Service Bulletin

Bulletin No.: PIP5122A

Subject: Pop Noise From Fuel Tank After a Cold Start or EVAP Purge Event (Equinox / Terrain)

Models: 2010 -2014 Chevrolet Equinox
2010-2014 GMC Terrain

(1) Flange location

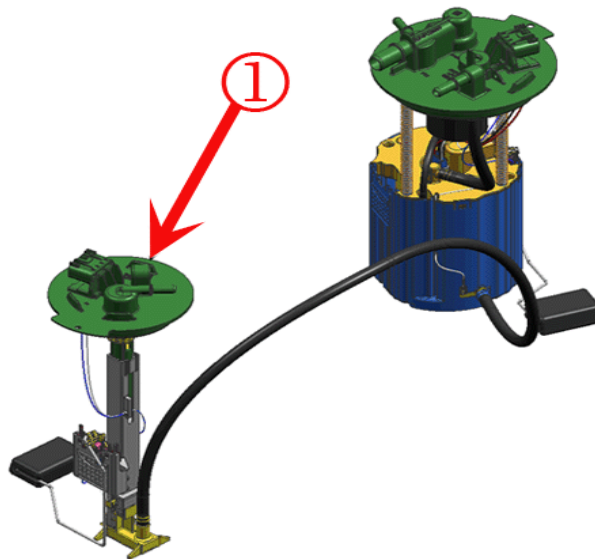
The part number on the box of the auxiliary fuel module has not changed but the auxiliary fuel module inside of the box has. After ordering the auxiliary fuel module, remove it from the box and verify the letters "PPA" are casted into the top of the fuel module flange. This is the revised auxiliary fuel module designed to correct the pop/popping noise. The original auxiliary fuel module has "POM" casted into the flange.
